TECHNICAL REVIEW REPORT

Prior Consultation for the Proposed Luang Prabang Hydropower Project

**Procedures for Notification,
Prior Consultation and Agreement**

Mekong River Commission

Figure 4-1 The change in monthly discharge reported in the BDP 2005, and using the water balance model.

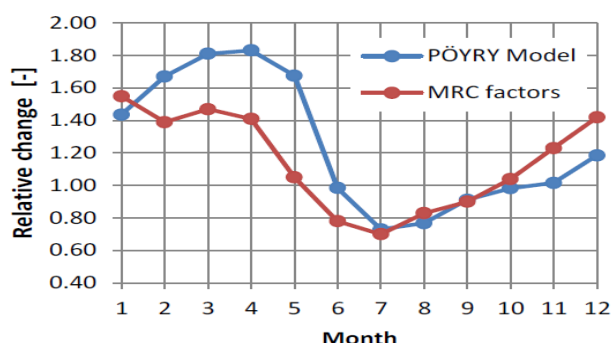
The documentation recognises the impacts of the operation of the large storage schemes at the Nuozhadu and Xiaowan hydroelectric stations in China. The monthly inflows have been calculated for the period 1960 – 1990 with and without the Lancang cascade. The impacts of the Pak Beng HPP and upstream tributary dams are ignored, as they are assumed to be minimal. The resulting monthly discharges have been compared with those in the MRC's BDP 2005. The results predict a higher increase of low flows than reported in the BDP (1.8 times increase compared to 1.4 times in the BDP) as shown in Figure 4-1. This reflects the different methodologies used to assess changes in the flow regimes in the two studies and illustrates the uncertainty around the future hydrology that should be accommodated in the design and financial viability assessments of the LPHPP. The results do not include the impacts of other tributary developments, such as hydropower development in the Nam Tha tributary and in Myanmar. More importantly, the operational rules for the Pak Beng HPP are not considered with respect to short term changes in flows²².

The developer concludes that the impacts of the upstream hydropower operations on the Lancang Cascade far outweigh any seasonal changes due to climate change, but recognises that potential changes in runoff may occur due to climate change. Various MRC studies have shown that both hydropower development and climate change affect both dry and wet season flows.

Figure 4-2 Results of the simulation of sediment deposition in the LPHPP reservoir.

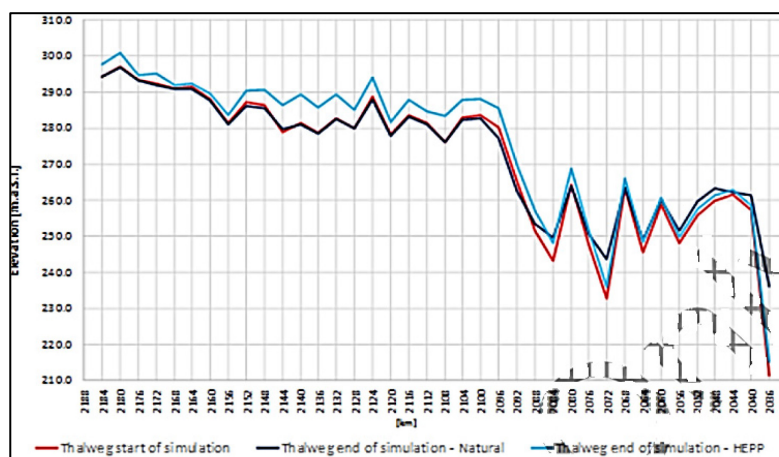
The model results show deposition throughout the impounded area, with higher potential in the area between km 2052 and 2164 (Figure 4.2).

Fine silt and clay sized material was generally transported through the impoundment, along with some coarse silt, whereas most of the fine sand material is deposited.

Figure 4-3 The more detailed longitudinal profile of the impounded reach.

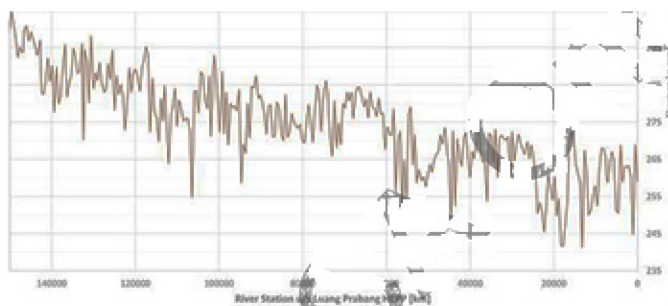
- The GSTAR model is a basic 1-D model sediment transport model. Flows are averaged across the cross section, which means the model cannot predict deposition across the impoundment profile. The FS recognises this and states that the model should be considered a '*rough estimate of the sediment transport processes*'. Understanding sediment transport is a significant transboundary issue and a more robust modelling approach should be applied to provide the most reliable information possible.
- The longitudinal section used for the sediment transport model is based on 38 cross-sections and parameters used for Xayaburi but has not been calibrated for Luang Prabang. The longitudinal section shows a relatively flat area in the upper section of

the impoundment and a large change in elevation between km 2100 and km 2082 (Figure 4-2). However, the more detailed longitudinal section in Figure 4-3 captures the high number of deep pools within the impoundment and shows a more continuous slope as compared to the model setup. These differences will affect the results, including a likely under estimation of the trapping efficiency by deep pools.

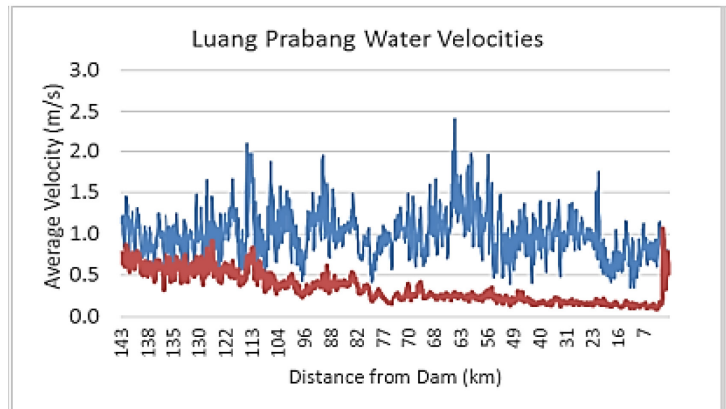
- The starting bed material is set at fine sand, based on sediment samples collected from riverbanks in April 2019 from the impoundment area. Bed materials are generally coarser than bank materials, and it is likely the grain-size present in the deeper channel is considerably coarser. Considering the high sensitivity of the model to the grain-size, incorporating a realistic grain-size for the channel is important and will affect the results.

- The modelling results show greater deposition in the upstream portion of the impoundment, and the FS states that the loss of material in this area contributes to a lack of deposition in the lower part of the impoundment. These results are not related to the characteristics of the channel.

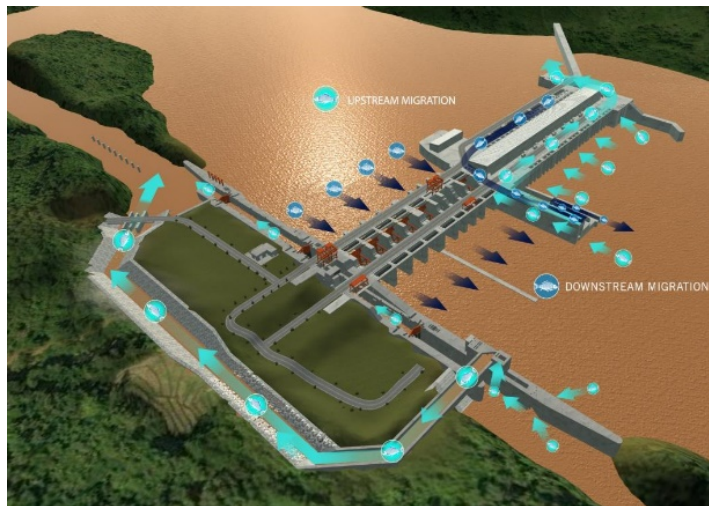
Issue: The proposed minimum tailwater for the LPHPP fishway needs to be adjusted in line with any new operating rules, minimum flows and the outcomes of the study on the tailwater rating curve.

Recommendations: Lower the minimum tailwater for the LPHPP fishway accordingly.

Figure 4-8 The existing debris screens (A), and a proposed new configuration (B).

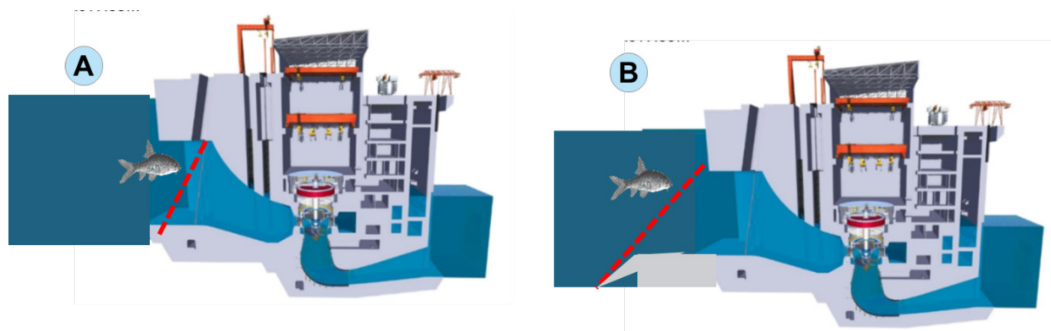
However, the present screen design is relatively perpendicular to the flow and does not direct fish to the bypass entrance. A screen angled as outlined may direct fish towards the entrances (Figure 4-8). Similar designs have been applied widely over the last few decades.

However, the developer has commented that tilting the trash rack is not possible as the trash rack cleaning machines require near vertical screens and the shape of the steel profiles will be optimised to reduce fish injury. However, as the design is still at the feasibility level, they have indicated that other design options will be explored. It is recommended that this is shared as part of the JAP process.

Figure 4-9 Options for baffle beams to reduce the risks of strong up-currents in the navigation locks.

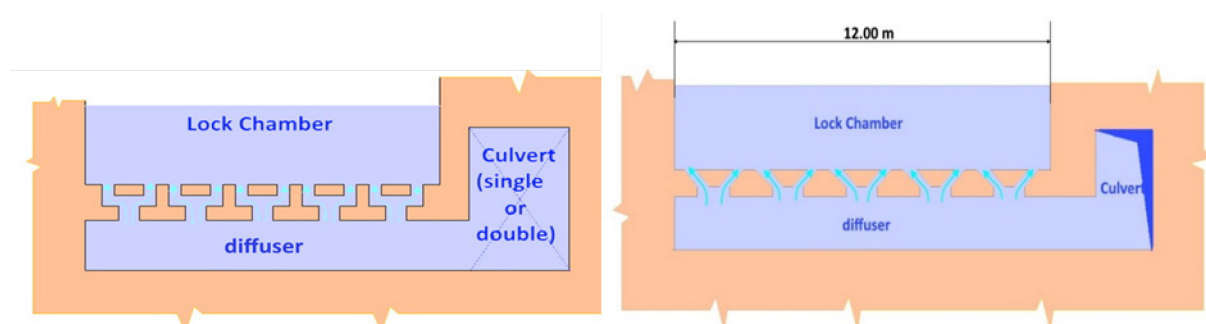
The filling of the chambers of the Navigation Lock is done via a gravity- based feeding system from the headwaters controlled by bonneted gates through a single culvert. Computational fluid dynamics (CFD) modelling of the water conduit system was undertaken to assess the hydraulic performance of the water feeding system. The bottom filling system consists of 7 diffusers with 5 openings each. However, the drawings do not indicate baffle beams to avoid strong vertical flows during filling. This may create mushroom shaped upward currents that will shake the vessels and the boats inside the lock chamber. It is consequently recommended that baffle beams are included in the design (Figure 4-9).

The developer suggests a single culvert filling system with three gates. The intake comprises three bays with a reported capacity of 100 m³/sec. However, the outlet comprises three bays with approximately 75% of the intake capacity, but the reported filling and emptying times are very similar. This discrepancy needs further explanation. The reported metrics are nonetheless consistent with good practice. Nonetheless, it is recommended that the culverts in the chamber walls are doubled. This can reduce the current velocity limiting the risk of cavitation and increasing reliability and substantially increases the operational capacity of the ship lock.

Figure 4-10. Diagram of the proposed LPHPP, showing the upstream and downstream approach channels to the navigation locks, and the islands that will be left after the excavations.

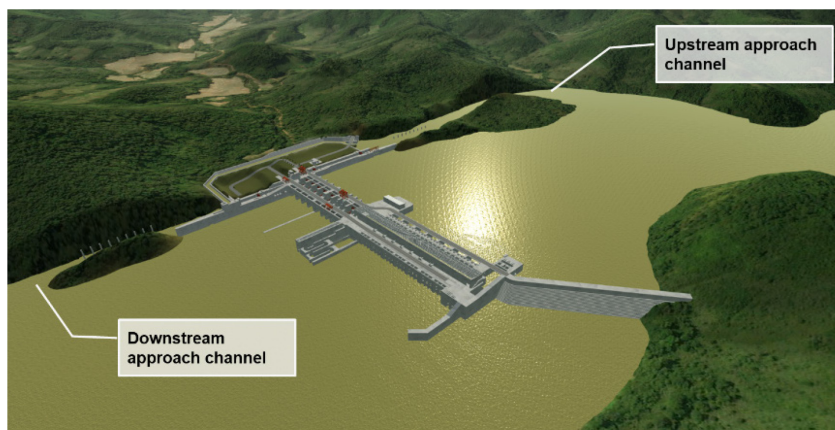
The approach channels are depicted in Figure 4-10. The two islands will be left over from the excavation works. The upstream island may obstruct the view of the entry to the locks and shipping in possible resting areas (if these are constructed as recommended), potentially posing a safety risk.

While reference is made to the PIANC recommendations for the access channels and the three areas in front of the ship lock, the documentation only mentions a single lay-by area, whereas the PIANC guidelines recommend 3 areas. At least two of these areas must be linked to the mainland and must include provision of fresh water, waste collection and power supply. The developer has verbally indicated that this is their intention.

Figure 5-1 The potential inundation of Luang Prabang City under a dam break or severe flood operations. A) shows the extent of inundation under the 100 yr, 1,000 yr, 10,000 yr and PMF as different colours. B) is a Google Earth image of the same area showing the infrastructure that would be affected.

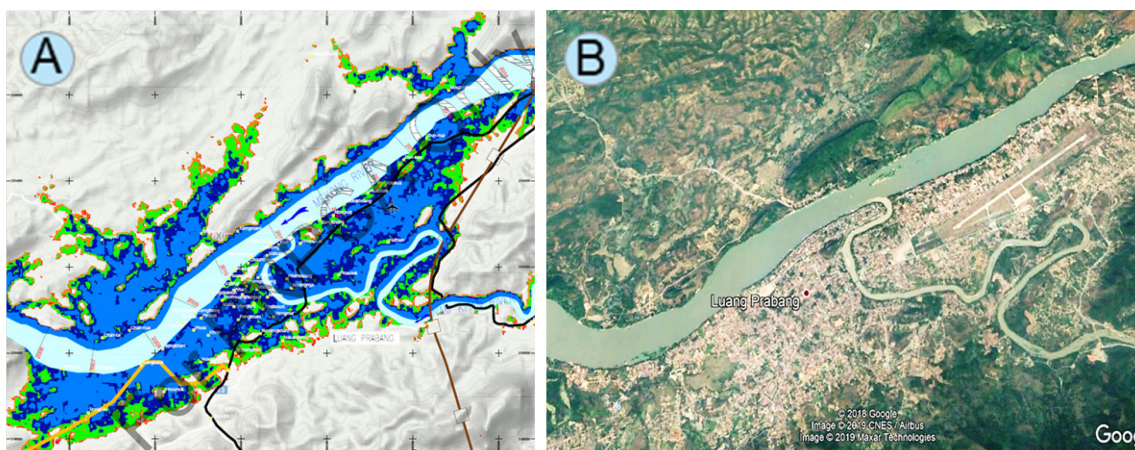
The LPHPP lies 25 km upstream of Luang Prabang City, which has been designated as a World Heritage Site. Any impacts of a dam break, or the flood operations may also lead to the loss of life for citizens from many countries. For the purposes of this TRR, impacts on Luang Prabang will therefore be considered as ‘transboundary in nature’, as this will be of concern to the global community. Figure 5-1 shows the likely inundation of the City under different flood operations. The dam break scenario shows similar levels of inundation. Because of the significant consequences of a dam break, the LPHPP should be designed using more stringent standards to those typical of the other HPPs in the cascade. The Emergency Procedures Plan has not yet been fully elaborated, but this is usually not expected at the feasibility level design.

The impacts of a dam break are therefore not considered to be substantially different from the very high flow conditions. However, as the dam break may be more likely when the head difference across the dam is greatest, the likelihood of a dam break may be higher than the extreme flood event, if adequate design parameters are not applied.
